# Access Compliance Report

## Public Rights-of-Way

### (Curb Ramps)

Intersection ID: 30117	Main Street: CLOONEY_LN	Cross Street: DAVIS_FOREST_LN	Location: N
ADA ID: 6E80B97E6C67	Ramp Type: PerpDiag	Initial Pass/Fail: Fail	Overall Compliance: No
		Severity Score: 8.75

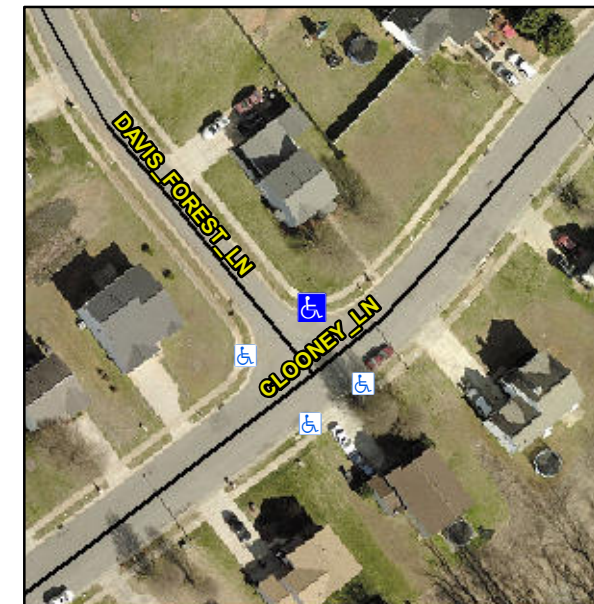
**R304.5.1**

Compliance	Description	Data	Compliance	Description	Data
N/A	Ramp Length (in)	45.0	Yes	Ramp Slope (%)	8.1
No	Ramp Width (in)	41.0	Yes	Ramp XSlope (%)	0.7
N/A	Flare Type LT	N/A	N/A	Flare Type RT	N/A
N/A	Flare Slope LT (%)	N/A	N/A	Flare Slope RT (%)	N/A
N/A	Flare Traversable LT?	N/A	N/A	Flare Traversable RT?	N/A
N/A	Landing Length (in)	N/A	N/A	DWS Provided?	N/A
N/A	Landing Width (in)	N/A	N/A	DWS Contrast?	N/A
N/A	Landing Slope (%)	N/A	N/A	DWS Length (in)	N/A
N/A	Landing X Slope (%)	N/A	N/A	DWS Full Width?	N/A
N/A	Landing Curb? (Y/N)	N/A	N/A	DWS Offset (in)	N/A
N/A	Shared Landing?	N/A			
N/A	Gutter Ponding?	Yes	N/A	Gutter Slope (%)	N/A
N/A	Gutter Lip Ht (in)	N/A	N/A	Gutter X Slope (%)	N/A
N/A	Painted X Walk1?	No	N/A	Painted X Walk2?	No
	X Walk 1 Direction	To SW		X Walk 2 Direction	To S
N/A	X Walk 1 Width (in)	N/A	N/A	X Walk 2 Width (in)	N/A
	X Walk 1 Slope (%)	2.2		X Walk 2 Slope (%)	0.3
	X Walk 1 X Slope (%)	2.4		X Walk 2 X Slope (%)	0.7

**Remove & Replace Curb Ramp With Two New Directional Ramps or Equivalent.**
